142-1721-881

REV 001 MARKUP
ECO 56952
D. CURTIS 2/22/18

TOLERANCE UNLESS OTHERWISE SPECIFIED		DRAWN BY JRK		DATE 11-3-04		 <div>cinch CONNECTIVITY SOLUTIONS <small>a bel group</small></div>	P.O. Box 1732 Waseca, MN 56093 1-800-247-8256	
DECIMALS .XX	mm _____	CHECKED BY		DATE			TITLE HIGH FREQ END LAUNCH SMA JACK ASSEMBLY, EDGE MOUNT, 15 MIL PIN	
.XXX ±.003	_____	APPROVED BY JRK		DATE 12-15-04				
MATL _____	RELEASE DATE 12-15-04		SHEET 2 OF 2		DRAWING NO. C - 142-1721-881/890			
FINISH _____	U/M INCH SCALE 10:1

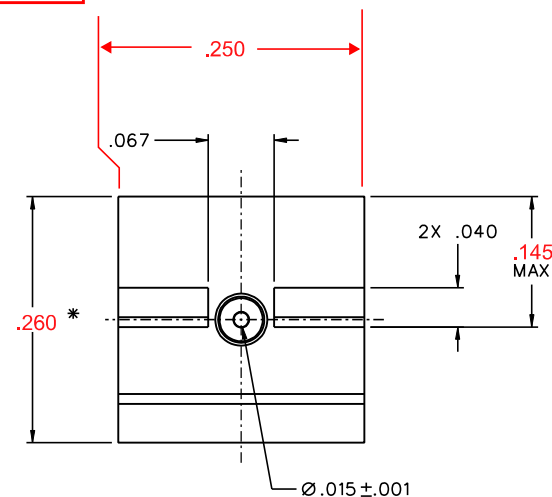
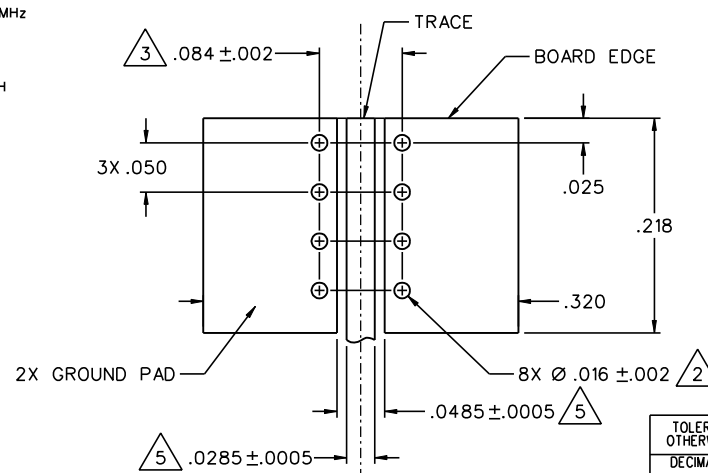
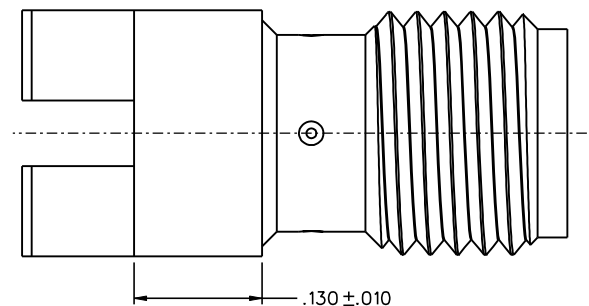
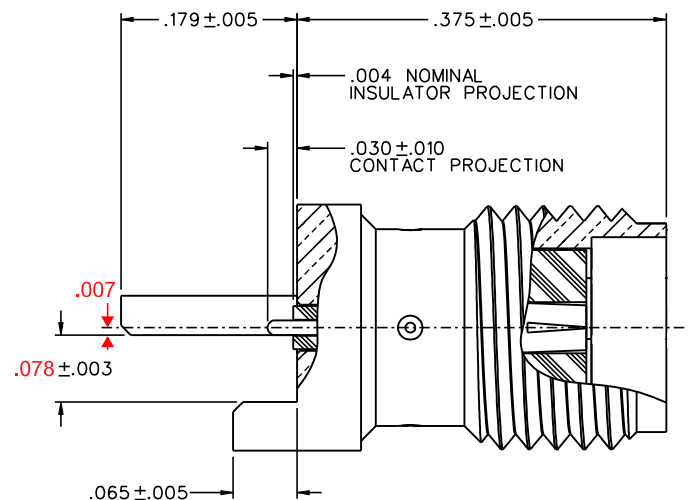
IMPEDANCE: 50 OHMS
 FREQUENCY RANGE: 0-26.5 GHz
 VSWR: 1.05+.02F(GHz) MAX AT 0-18 GHz, TYPICALLY < 1.50 AT 18-26.5 GHz
 WORKING VOLTAGE: 170 VRMS MAX AT SEA LEVEL
 DIELECTRIC WITHSTANDING VOLTAGE: 500 VRMS MIN AT SEA LEVEL
 INSULATION RESISTANCE: 1000 MEGOHM MIN
 CONTACT RESISTANCE:
 CENTER CONTACT - INITIAL 3.0 MILLIOHM MAX, AFTER ENVIRONMENTAL 4.0 MILLIOHM MAX
 OUTER CONDUCTOR - INITIAL 2.0 MILLIOHM MAX, AFTER ENVIRONMENTAL NOT APPLICABLE
 CORONA LEVEL: 125 VOLTS MIN AT 70,000 FEET
~~INSERTION LOSS: NOT APPLICABLE (DEPENDANT UPON APPLICATION)~~
~~RF LEAKAGE: NOT APPLICABLE~~
 RF HIGH POTENTIAL WITHSTANDING VOLTAGE: 335 VRMS MIN AT 4 AND 7 MHz
